ARTICLE 14. ONE AND TWO FAMILY DWELLING CODE

Rule 2.1. CABO One and Two Family Dwelling Code; Amendments

FIGURE R502.8
CUTTING, NOTCHING AND DRILLING

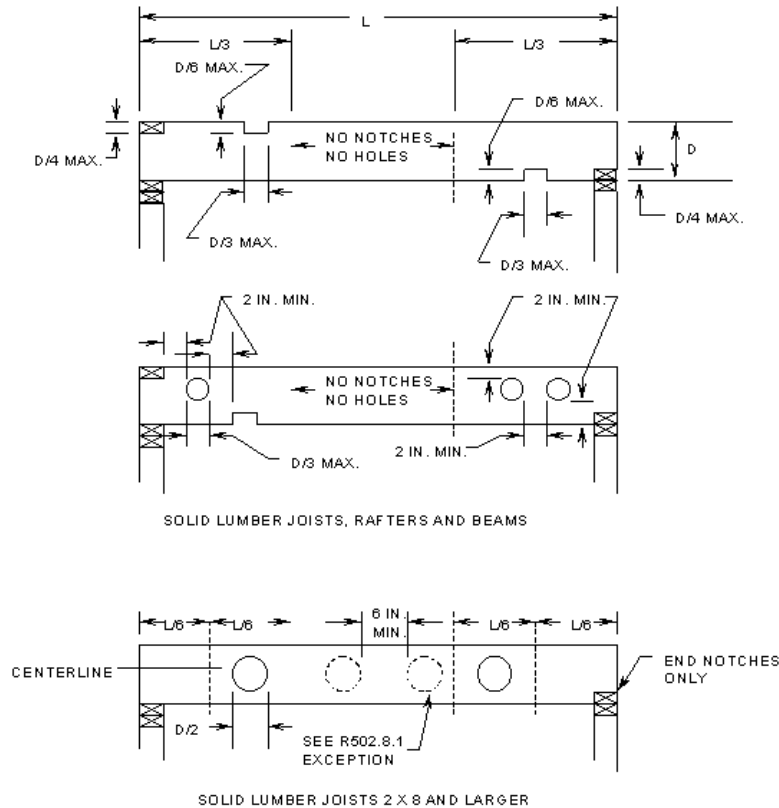
Sec. 88. Delete FIGURE R502.8 and substitute as follows: FIGURE R502.8:

FIGURE R602.6(2)
NOTCHING AND BORED HOLE LIMITATIONS FOR INTERIOR NONBEARING WALLS

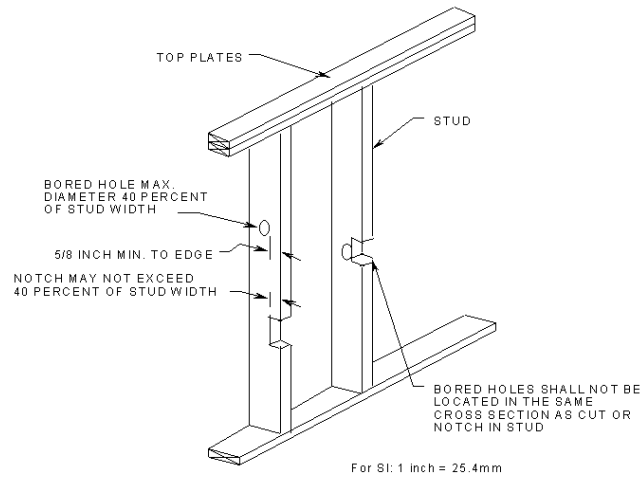
Sec. 95. Delete FIGURE R602.6(2) and insert FIGURE R602.6(2) to read as follows:

FIGURE R602.10.5(2)
GARAGE DOOR BRACED WALL PANEL FOR USE WITH CONTINUOUSLY SHEATHED WALLS

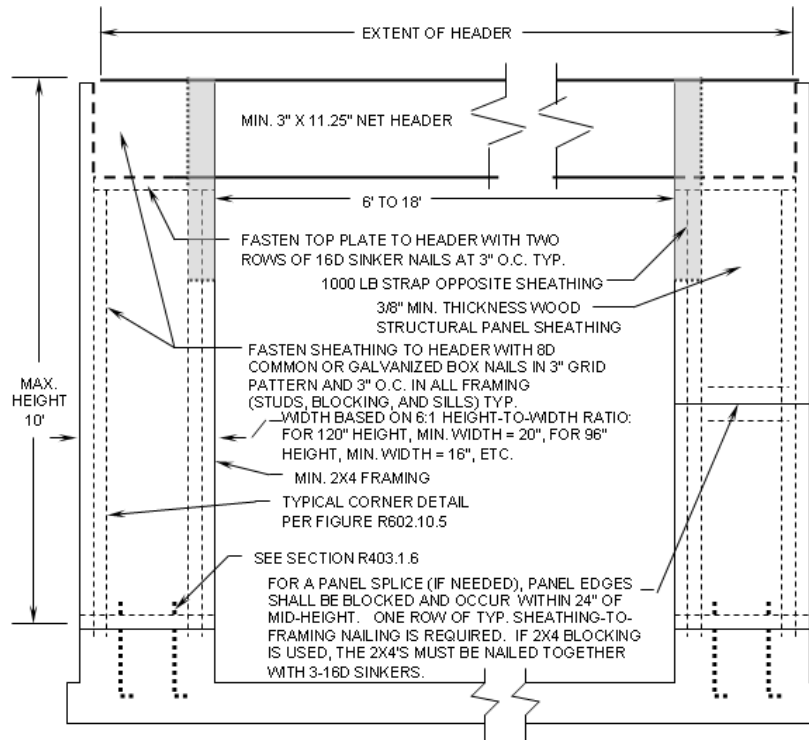
(4) Add FIGURE R602.10.5(2) to read as follows:

FIGURE R703.7.6(2)

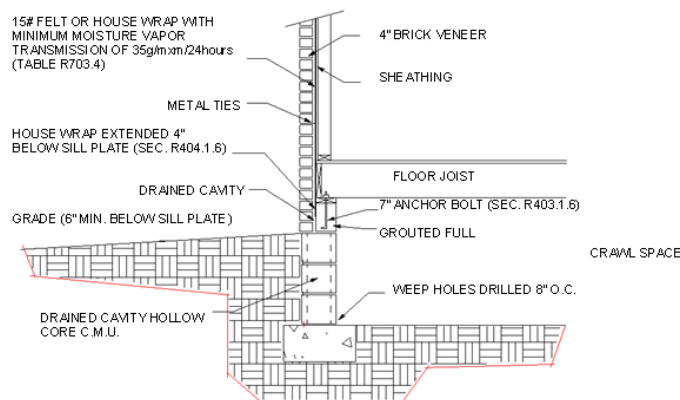
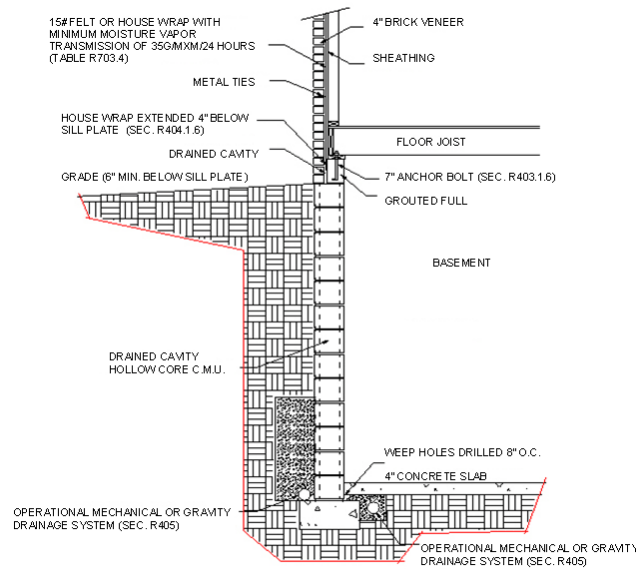
Sec. 121. Delete the title and text of SECTION R703.7.6 and substitute as follows: R703.7.6 Drained cavity. The 3/4 inch (19 mm) air cavity shall be drained to the exterior of the structure at intervals of not more than 33 inches (838 mm) on center. Each drain shall be not less than 3/16 inch (4.8 mm) in diameter, located immediately above the flashing. For dwellings with crawl spaces, the air cavity may be drained as shown in FIGURE R703.7.6(1). For dwellings with basements, the air cavity may be drained as shown in FIGURE R703.7.6(2).

FIGURE E3801.4.1

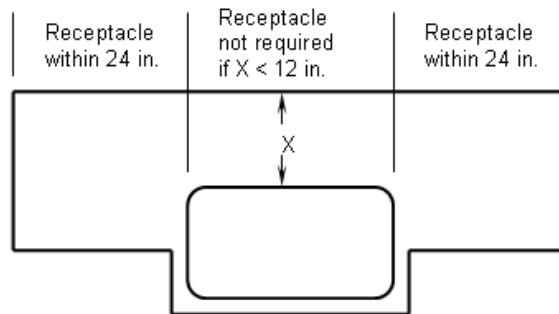
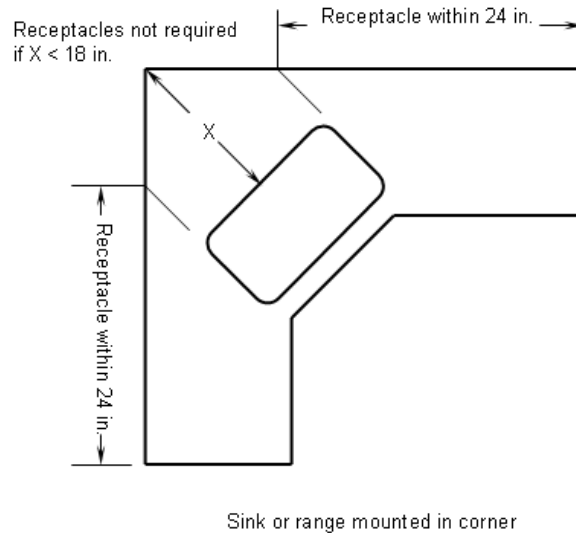
Sec. 229.5. (a) After SECTION E3801.4.1, add an exception to read as follows: Exception: Receptacle outlets shall not be required on a wall directly behind a range or sink in the installation described in FIGURE E3801.4.1.

(b) After SECTION E3801.4.1, add FIGURE E3801.4.1 as follows:
